Application no 10/642,813
Application Dated August 19,2003
Reply to office action of October 25,2006

Amendments to the Drawings:

REMARKS/ARGUMENTS

Fig 3.A

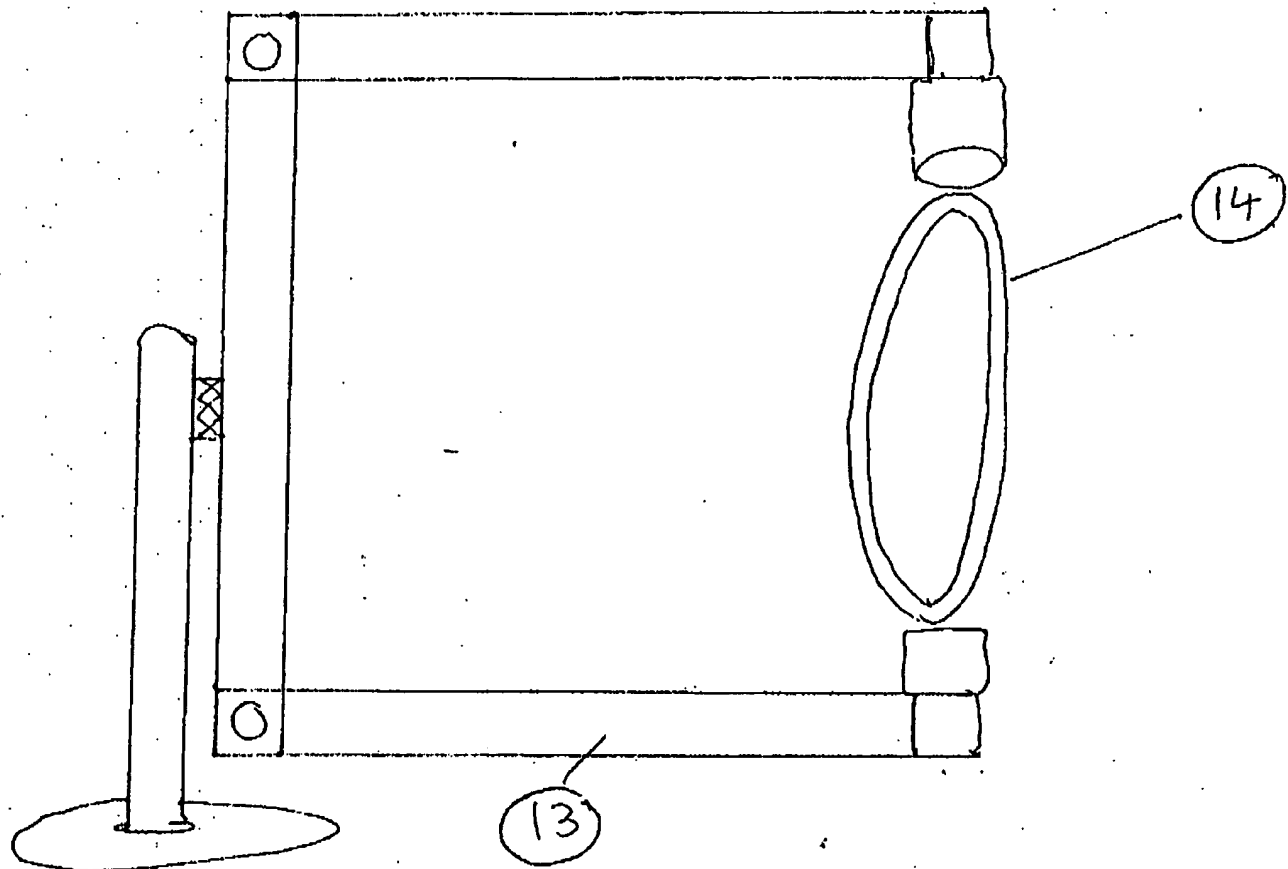
Fig 3.A

Legend "Prior art" has been added

Fig 3 A is amended as desired

Prior Art (added)
